Artistic Design Ltd.(Extension)

18th August 2019

Discrepancies in between as built drawing and actual site condition

Observations: Utility Building

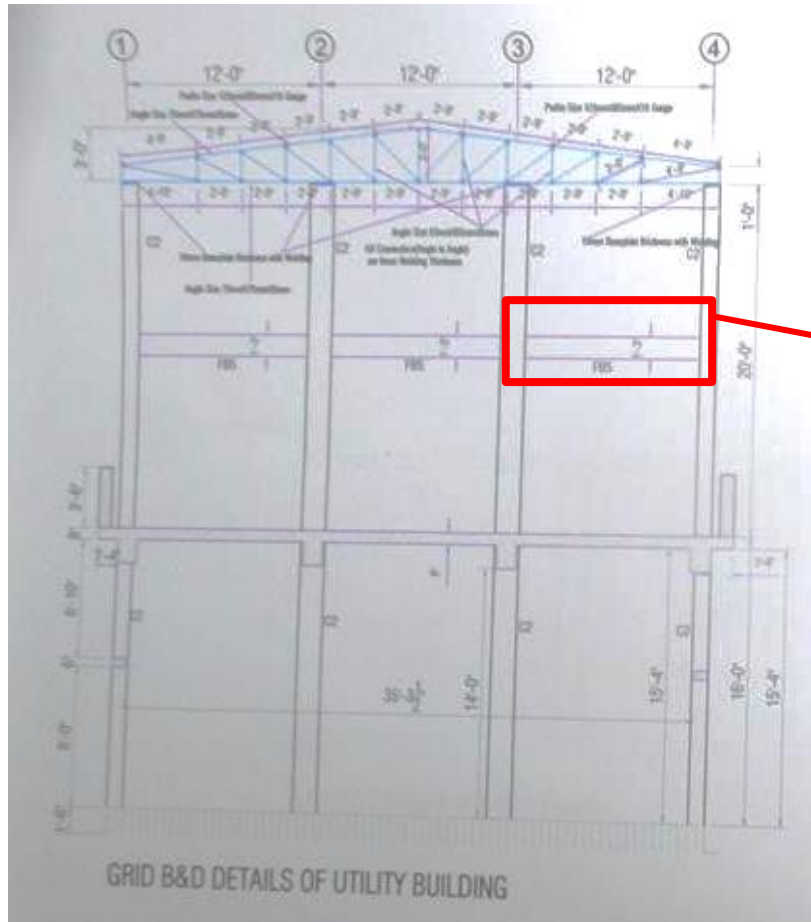
Truss shown along grid-C in drawing. But at on site channel section was found at that location.

Sectional elevation

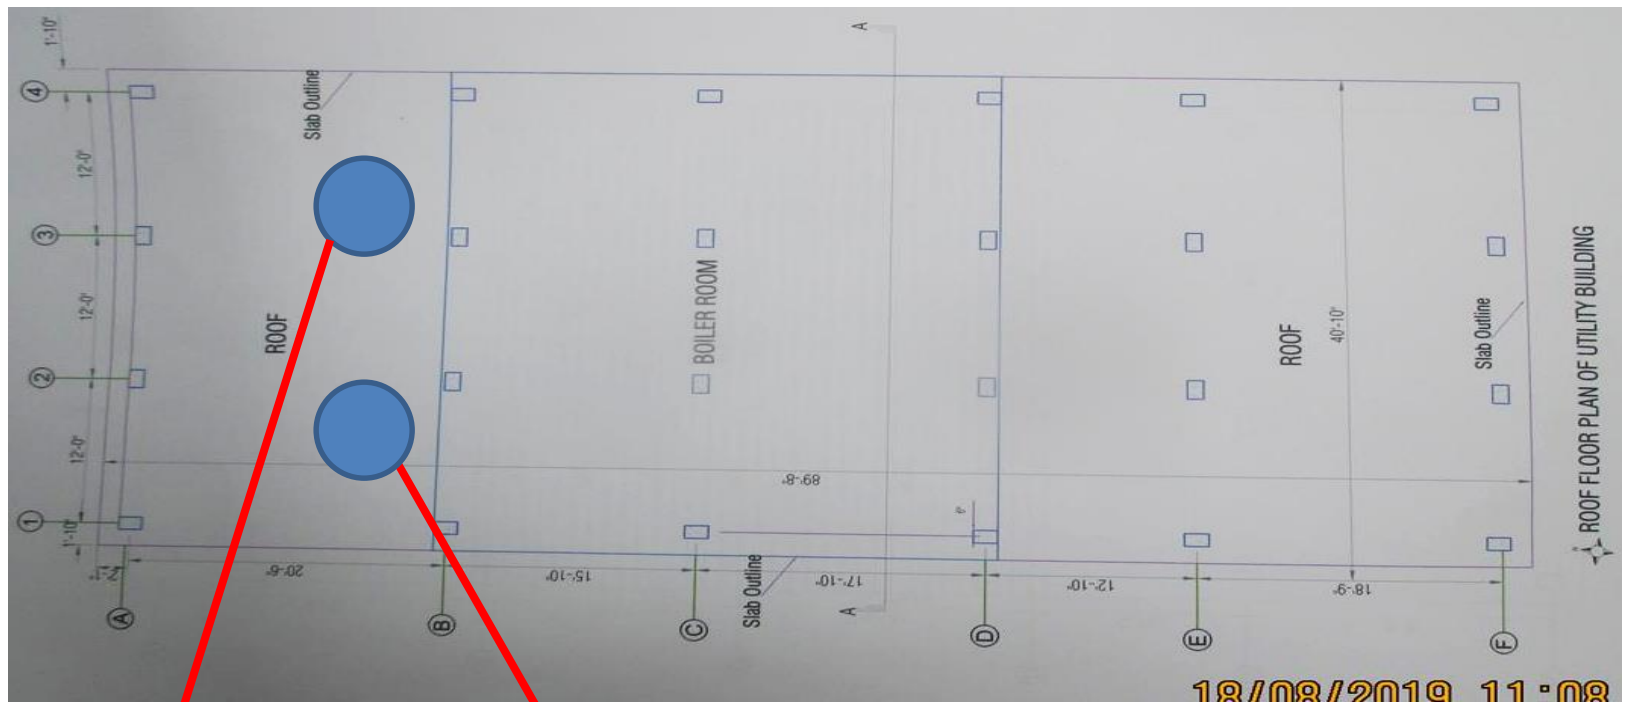
Arrangement of tie beam was found mismatch with site condition at roof level. The marked beam was found elevated from the regular height as shown in drawing

Roof floor layout

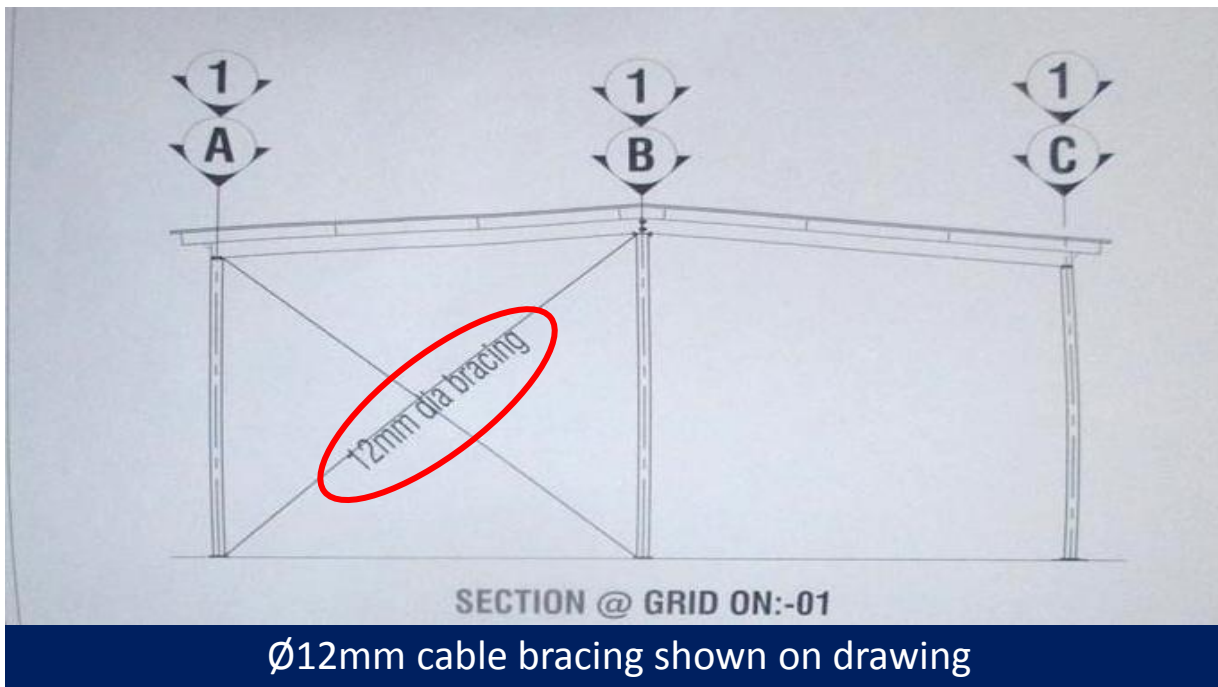
Undocumented cooler/chiller was found at roof top of utility building. The cooler/chiller has not been shown in as-built drawing.

Observations: Dinning Shed

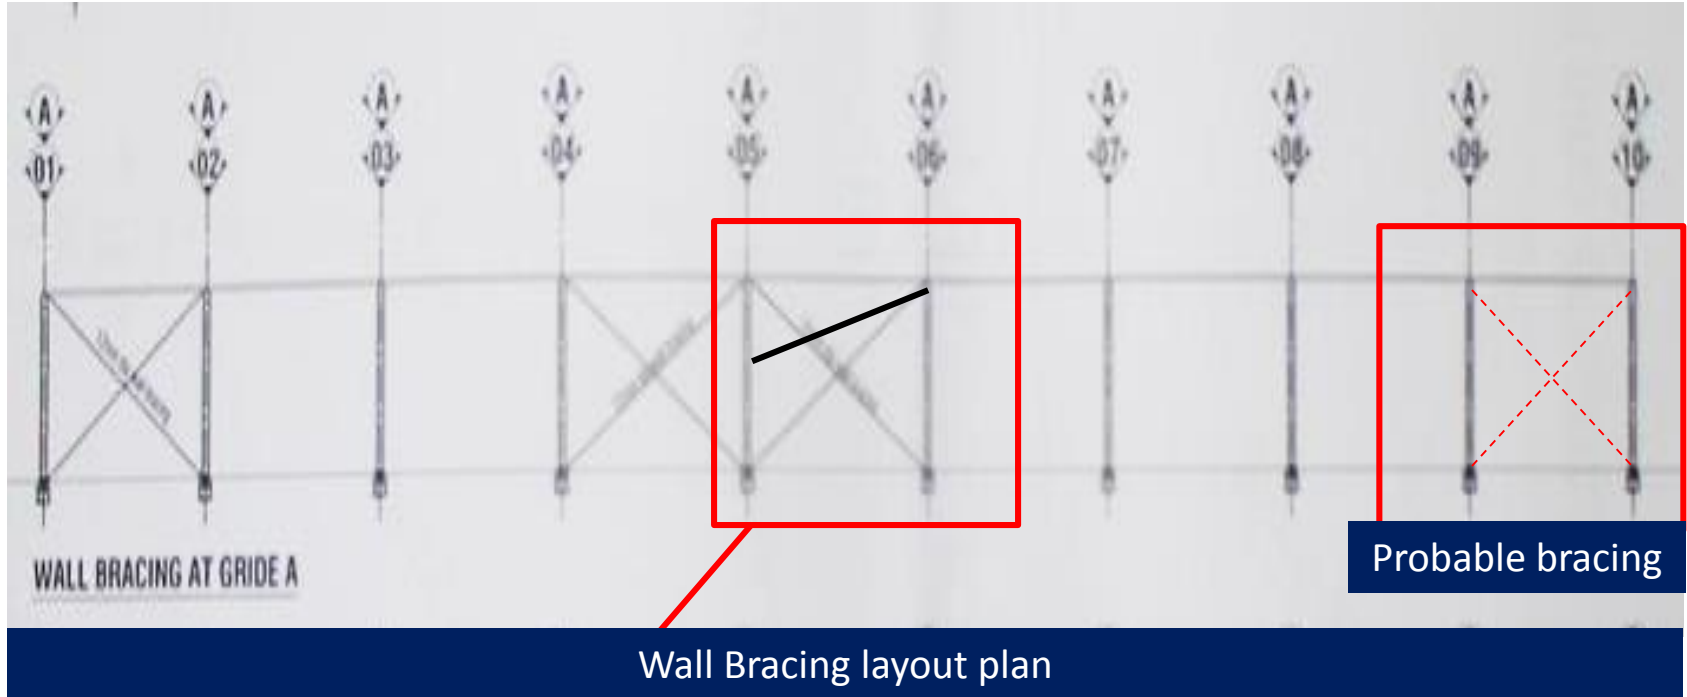
cable bracing was found Ø10mm instead of Ø12mm.

Installation of wall bracing in as-built drawing does not match with actual site condition. Due to door opening bracing arrangement has been changed. Also asymmetric bracing system observed. Factory engineer is required to survey the actual site condition and prepare as constructed as built drawing.

Loose cable bracing

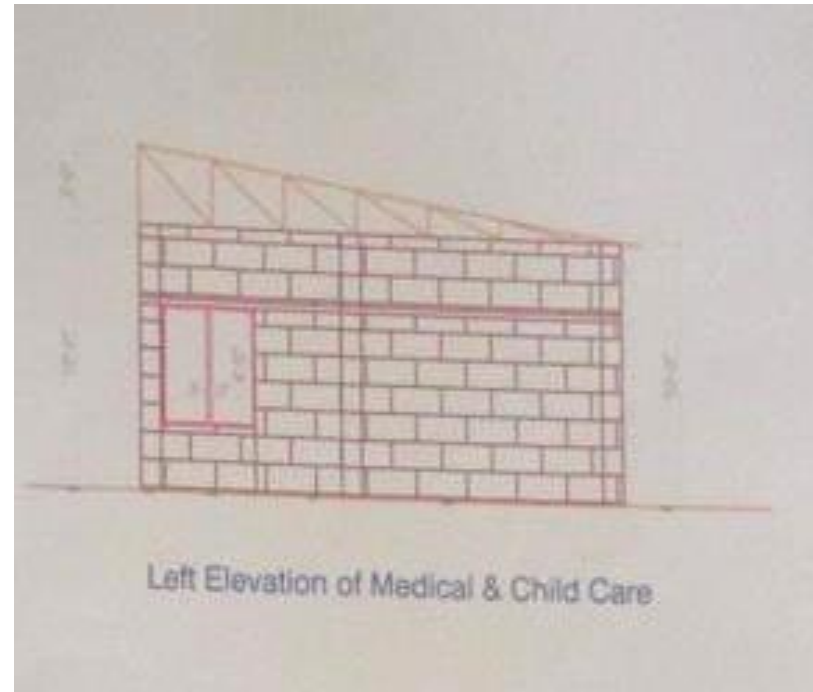
Bracing was found loose on site.

Item No.	Observation	Recommended Action Plan	Recommended Timeline
5	Loose cable bracing(Dinning shed)	Factory is required to tighten the loose bracings.	6-weeks
6	Lack of as-built documentation(Medical & Childcare)	Factory Engineer to survey the structure and update the full set of architectural and structural “as-constructed” drawings.	6-weeks
7	Lack of as-built documentation(Medical & Childcare)	Building engineer is required to check the lateral stability system of the existing structure.	6-weeks
8	Lack of as-built documentation(Medical & Childcare)	Complete remedial works as per the recommendation of engineering assessment.	6-months

Non-engineered roof shed

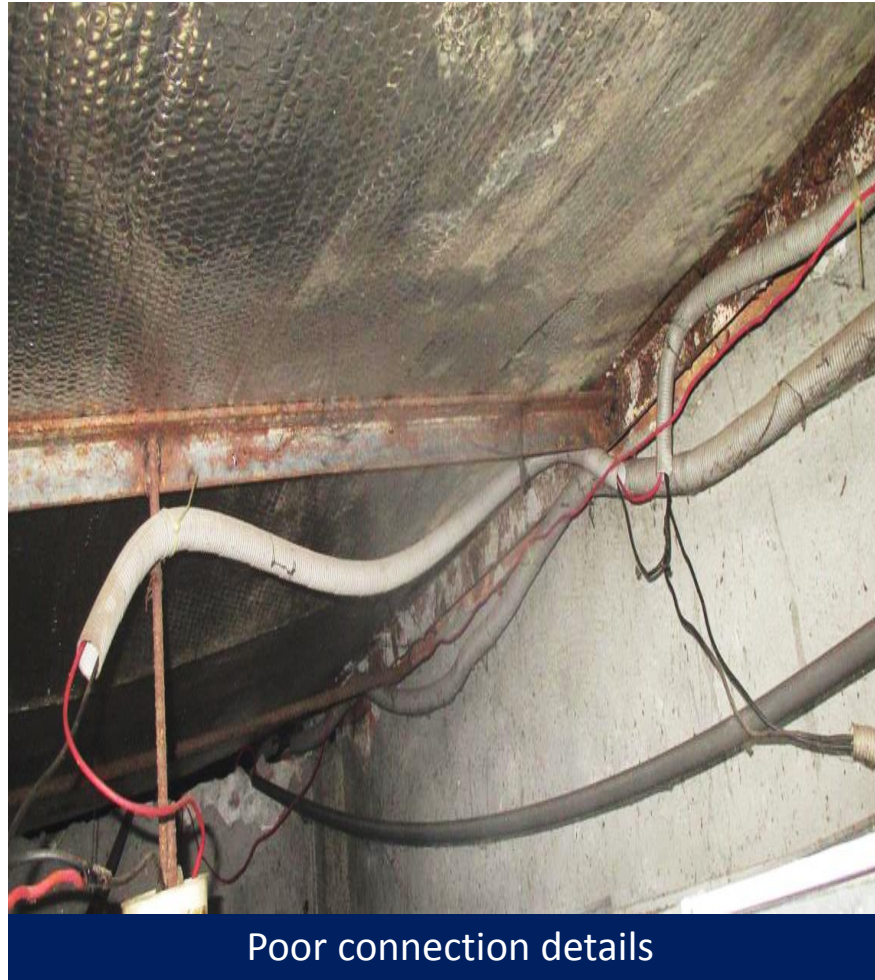
Roof truss shown in as-built drawing, but onsite truss wasn't found. Non-engineered steel roof shed supported by masonry structure. Inadequate connection of shed with brick wall. No definite arrangement of angle members. Factory engineer is required to survey the site condition and prepare as-built drawing. Factory engineer is also required to check the adequacy of the roof shed against lateral loading.
